Product Change Notification

1. ECR #: 213435
Notification #: 634

- ISDE - 0.8MM SESD BODY
- SESDT - 0.80MM SOCKET DISCRETE WIRE ASSEMBLY

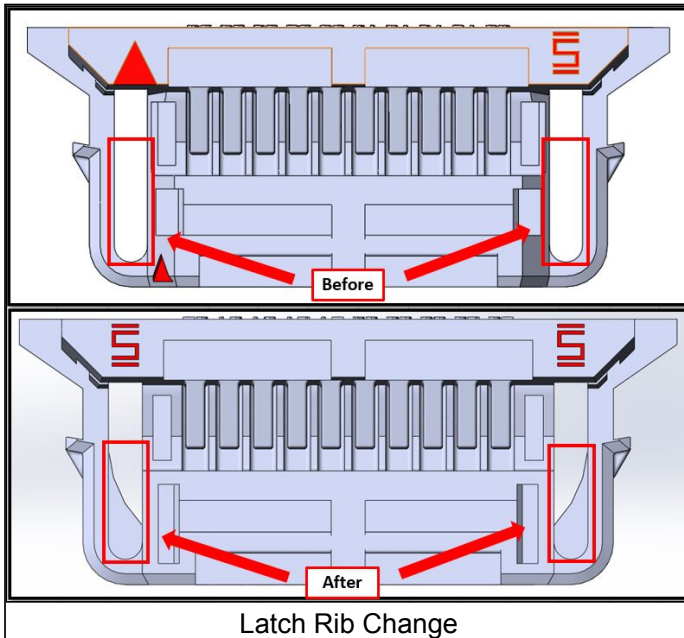
Adding ribs underneath both latch arms.

Improve latching action by updating latch geometry to current design standard. This will not be a rolling change and only new revision bodies will be received after this change is complete.

- Form - Visual change with adding ribs underneath the latch arm.
